PG&E Letter DCL-13-081

Pacific Gas and Electric Company's First Six-Month Status Report in Response to  
March 12, 2012, Commission Order Modifying Licenses with Regard to  
Requirements for Mitigation Strategies for Beyond-Design-Basis External Events  
(Order Number EA-12-049)

**Pacific Gas and Electric Company's First Six-Month Status Report for the Implementation of NRC Order EA-12-049**

Figure 6E  
 RHR Crosstie Connection Point  
 Unit 1

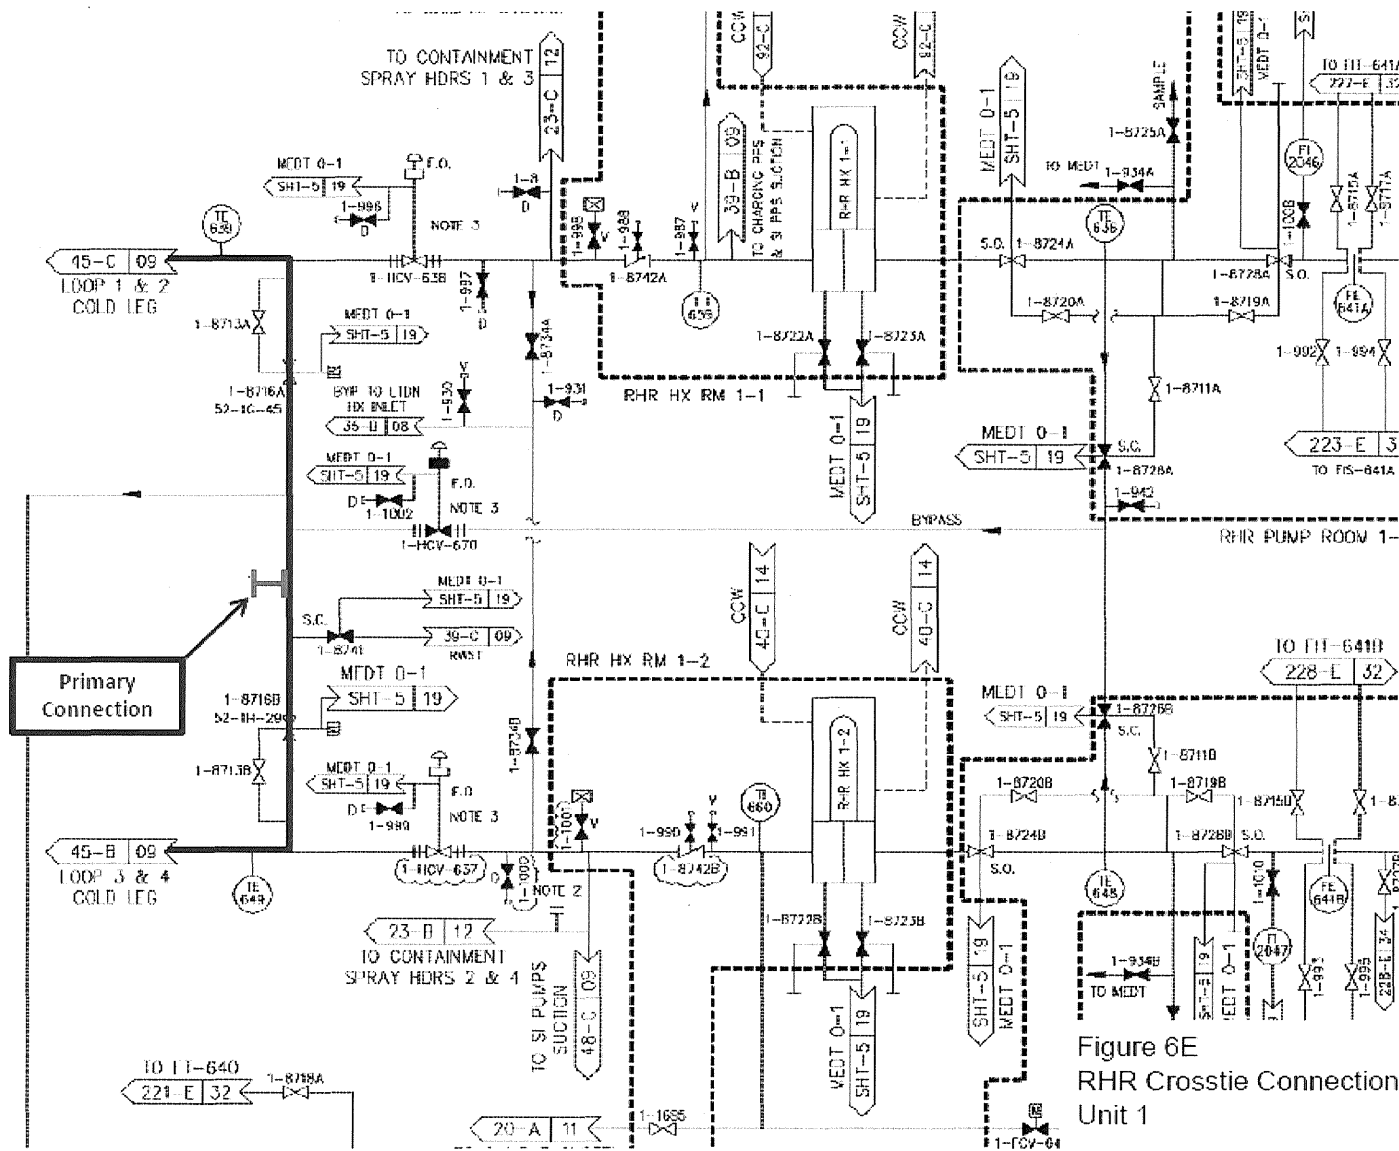
- (1) The primary connection point location when steam generators (SGs) are not available is moved from the boron injection tank room on the safety injection line to the residual heat removal (RHR) crosstie line on the 100-foot elevation in each unit. The crosstie line will be modified to add a valve with a standardized hose connection in each unit. The deployment path from the emergency auxiliary feedwater (EAFW) pump to the primary and alternate connection points is changed. OIP Figures 6C, 6D, 7C, 7D, and 9C have been deleted. OIP deployment path Figures 6B, 7B, 8A, 9A, 9B, and 9D are revised. Attachment A provides the location of the RHR crosstie connection point for Unit 1 (Figure 6E) and the location of the RHR crosstie connection point for Unit 2 (Figure 7E).

The new primary connection point will provide the flow necessary for cooling without SGs available. The RHR crosstie line is safety-related and seismically qualified and is in an area that is accessible to facilitate hose installation from the EAFW pump. The deployment path to the primary connection ends at the 100-foot elevation instead of the 73-foot elevation due to the connection point change. The deployment path to the alternate connection is an improved path.

Figure 10  
BAST Suction Connection Point  
Unit 1

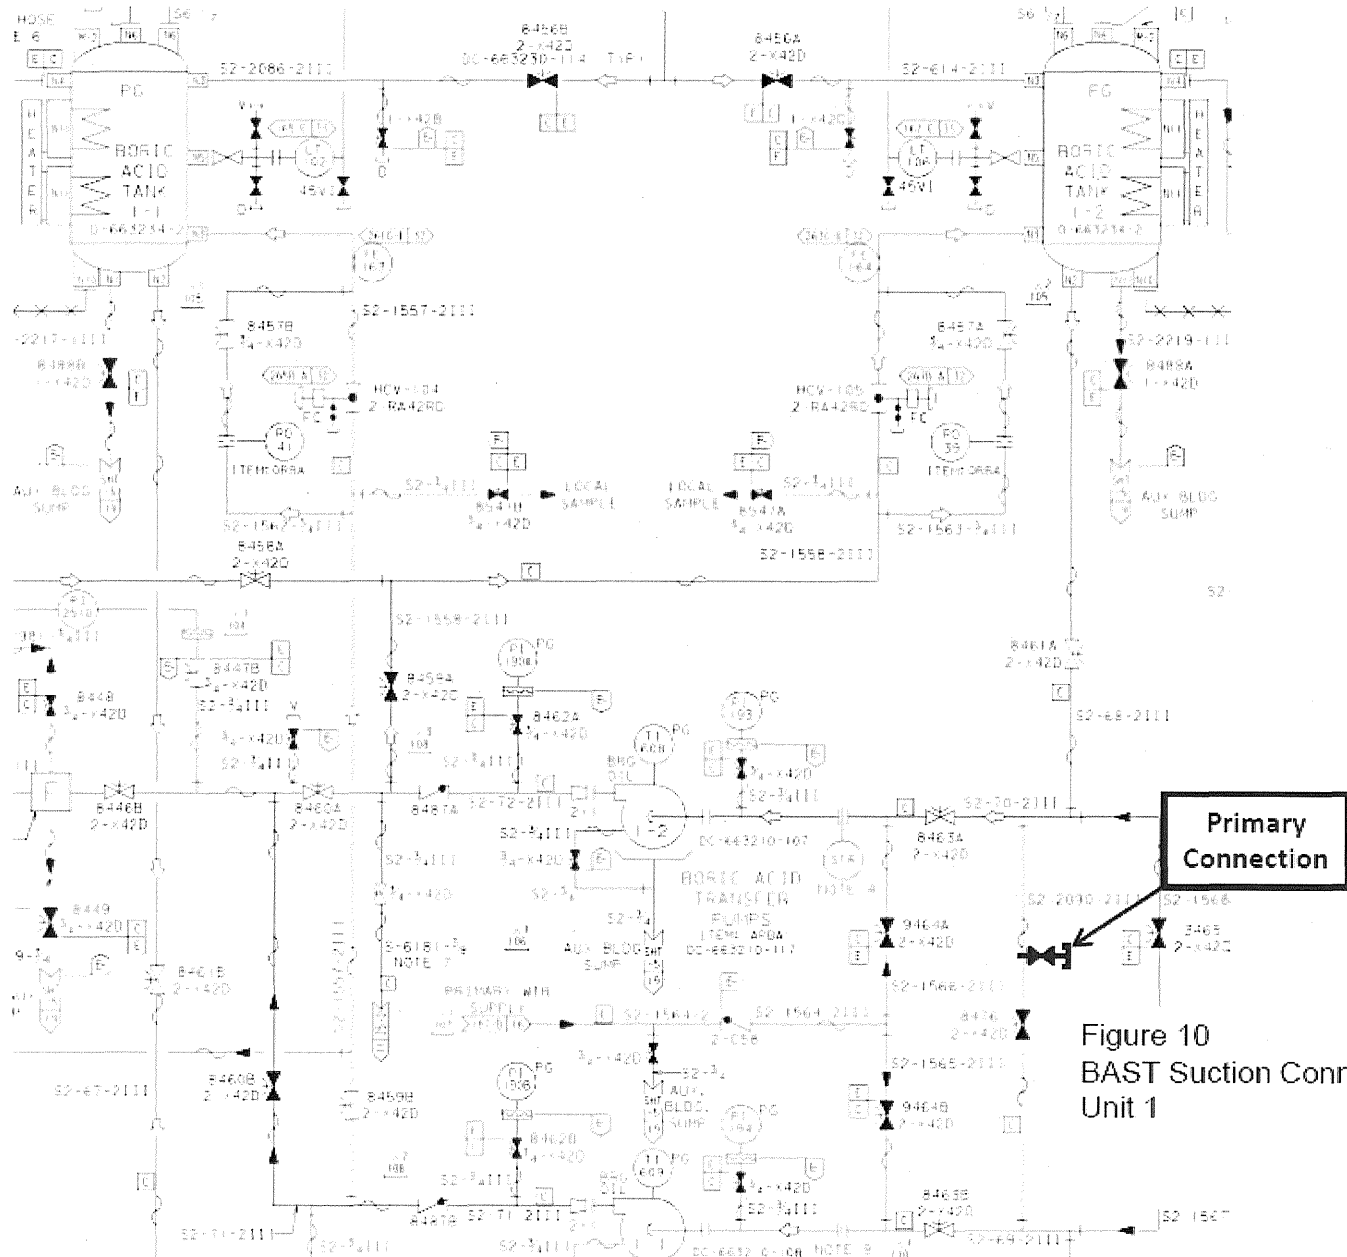
- (1) The suction connection point from the terminated line at the bottom of the boric acid storage tank (BAST) is changed to the boric acid transfer pump suction crosstie line in each Unit. The crosstie line will be modified to provide for a valve and hose connection in each unit. The deployment path from the emergency reactor coolant system (ERCS) pump is changed in each unit. OIP deployment path Figures 6A, 6B, 7B, 8A, 8B, and 9B are revised. Attachment A provides the location of the BAST suction connection point for Unit 1 (Figure 10) and the BAST suction connection point for Unit 2 (Figure 11).

The new connection point allows each connection to draw from the associated unit's BASTs. The crosstie line is safety-related and seismically qualified and is in an area that is accessible to facilitate suction hose connection. The deployment path change was made due to the revised connection point and is an improved path.
